RS-13-115

Byron Station, Units 1 and 2
Facility Operating License Nos. NPF-37 and NPF-66
NRC Docket Nos. STN 50-454 and STN 50-455

Subject: First Six-Month Status Report in Response to March 12, 2012 Commission Order Modifying Licenses with Regard to Requirements for Mitigation Strategies for Beyond-Design-Basis External Events (Order Number EA-12-049)

First Six-Month Status Report for the Implementation of Order EA-12-049, Order Modifying Licenses with Regard to Requirements for Mitigation Strategies for Beyond-Design-Basis External Events

Updated one line diagram

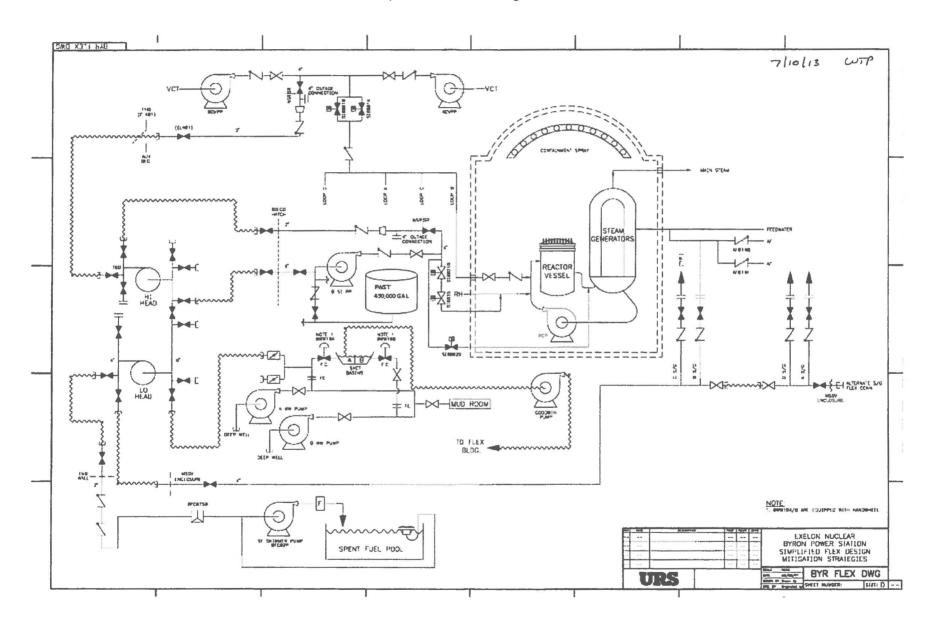
Section: Attachment 3, Conceptual Sketches

Reason for Change: Modification design details were refined as part of the standardized modification design process resulting in changes to the mechanical and electrical power conceptual sketches.

Change: Current mechanical conceptual sketch is attached to this document.
